Car Stereo
Service Bulletin

Model: XR-U220/U330/U550/U660 **No.** 322

Subject: Loses Memory Presets; Clock Resets To 1:00 **Date:** May 13, 1994

XR-U220/U330

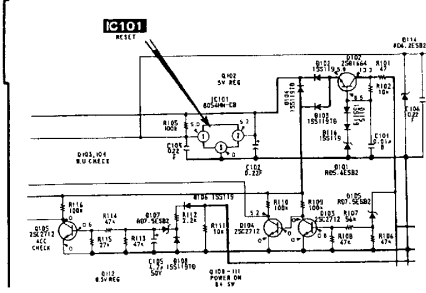
Symptom:
(13) The memory presets are lost, and the clock resets to 1:00.

Solution: Replace reset IC101 on the Main board for the XR-U220 and XR-U330, or IC504 on the Main board for the XR-U550 and XR-U660.*
